Amendments to the Drawings:

The attached replacement sheets of drawings includes changes to Figs. 1, 3 and 7 and replaces the original sheet including Figs. 1, 3 and 7.

The examiner objected to the drawings of FIGS. 1, 3 and 7 under 37 C.F.R. § 1.84(p)(5). In response, applicant amended the drawings to make the corrections requested by the examiner.

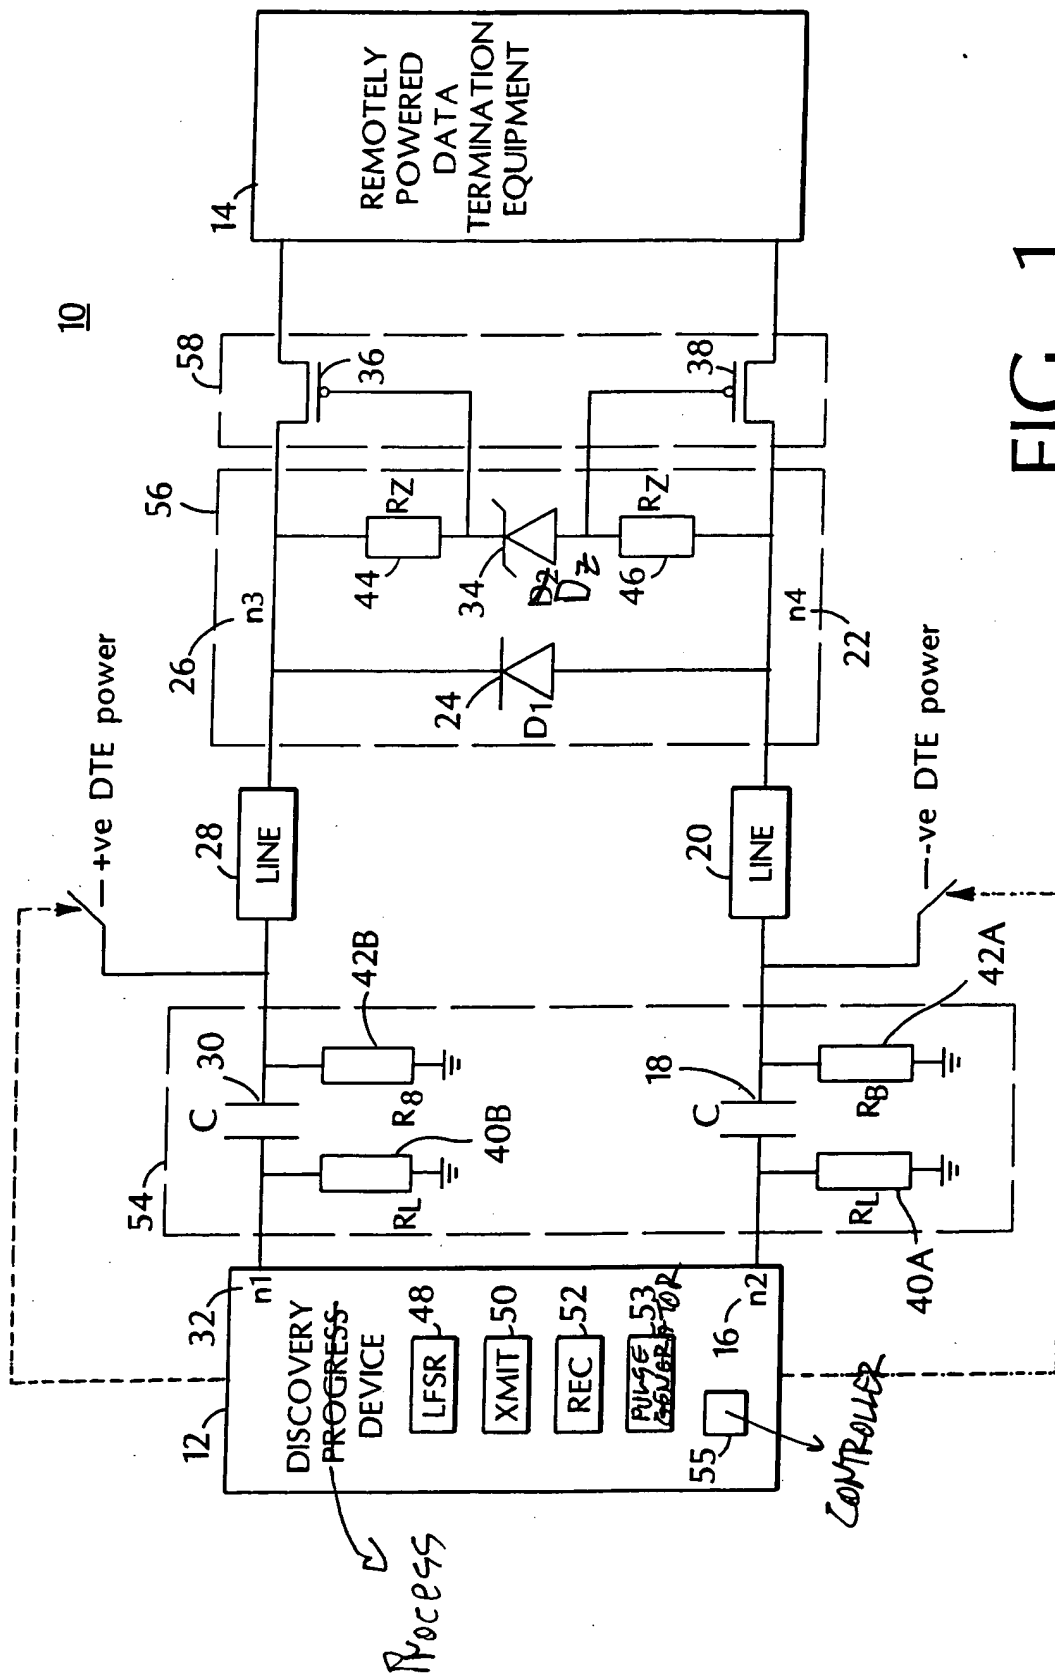
In Figure 1, applicant replaced the reference "D<sub>2</sub>" with "D<sub>z</sub>", replaced the word "PROGRESS" appearing in item 12 with "PROCESS", and added a the descriptors "PULSE GENERATORS" and "CONTROLLER" to items 53 and 55, respectively, within item 12 .

FIG. 3

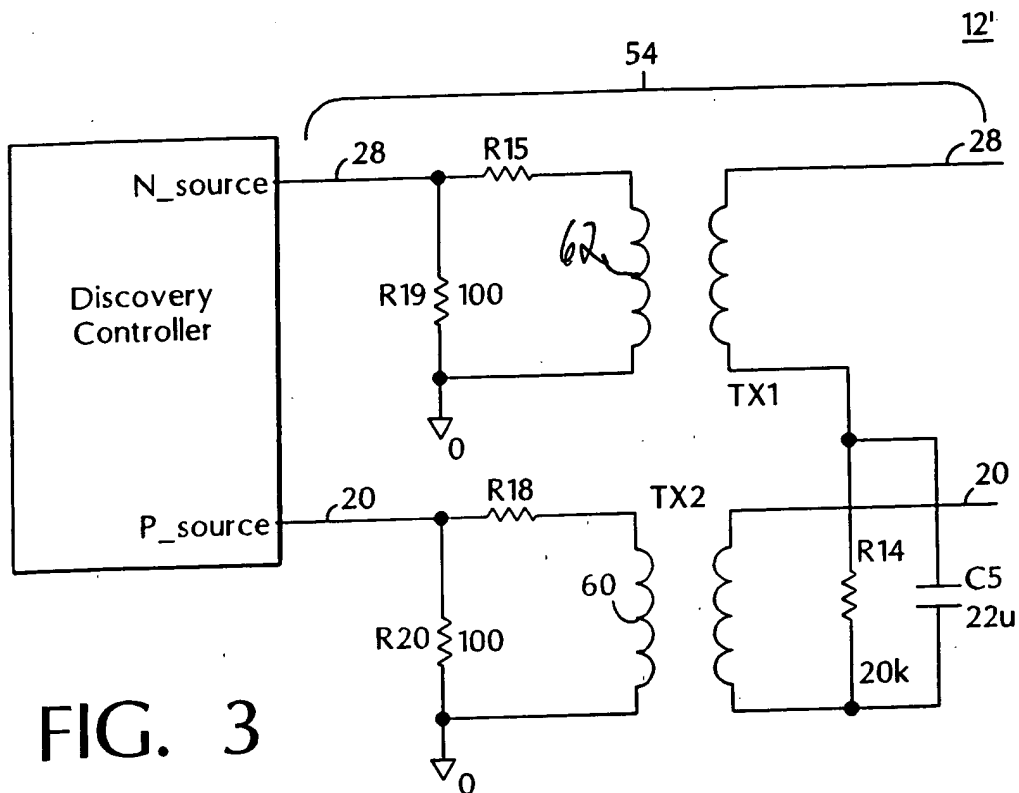
In Figure 3, applicant added the reference numeral 62 to the transformer coupled to receiver line 28.

FIG. 7

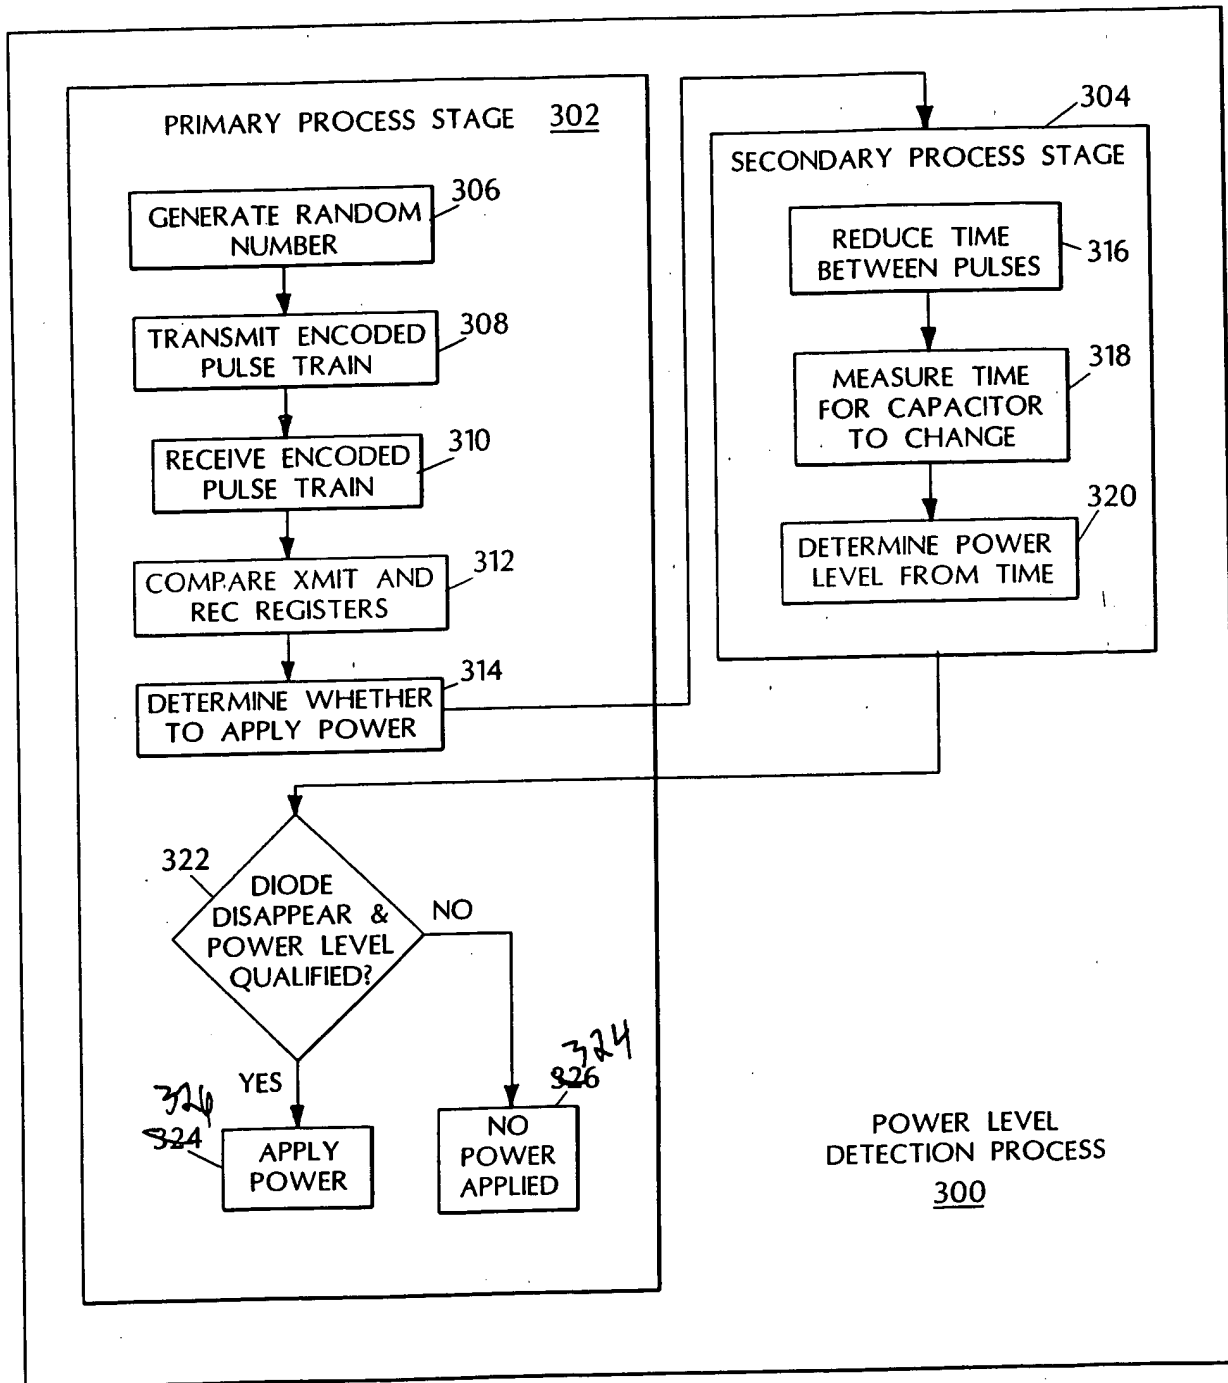
In Figure 7, applicant amended the drawing to switch reference numerals 324 and 326 so that the corresponding items are marked in a manner consistent with the Description of the above-identified application.
